UNITED STATES PATENT AND TRADEMARK OFFICE

10/500,191

Office Action Summary	Application No. 10/500,191	Applicant(s) SANO, MASAHIRO	
	Examiner Geoffrey L. Knable	Art Unit 1733

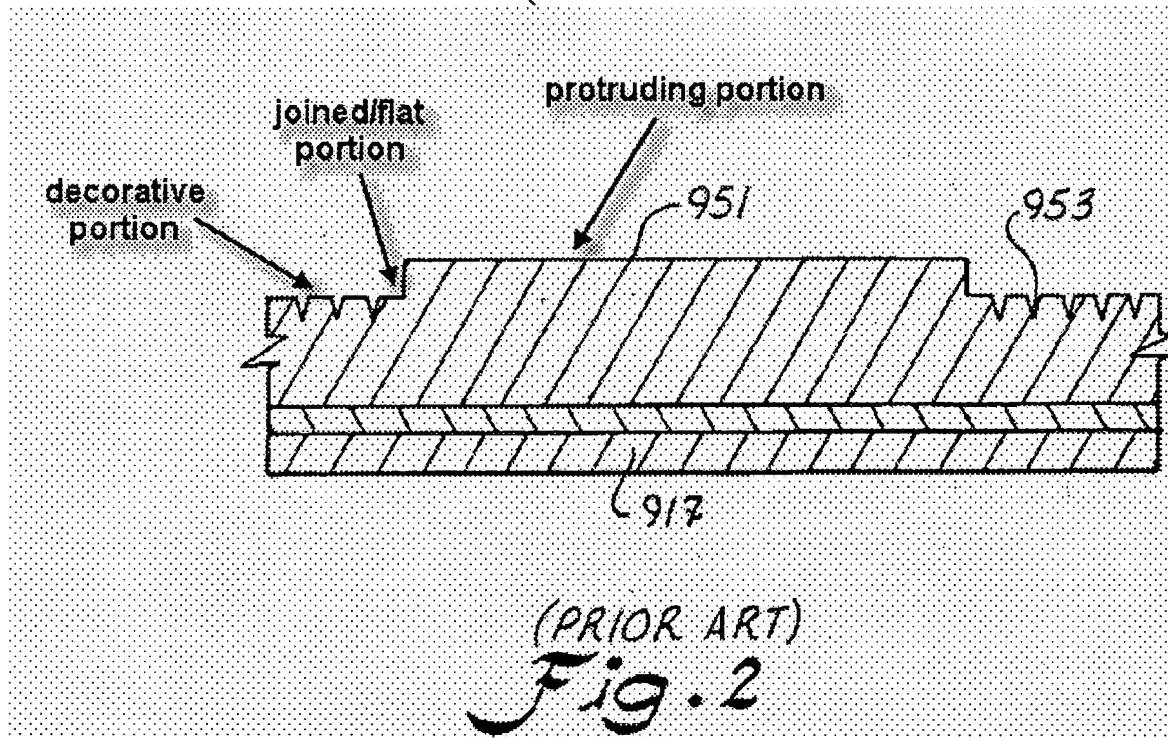
Kemp et al. discloses a tire having a sidewall patterning that includes decorative, joined/flat and protruding portions that are considered to satisfy the claimed requirements - note the following marked up copy of fig. 2:

A tire as required by claims 1 and 3 is therefore anticipated by this disclosure.
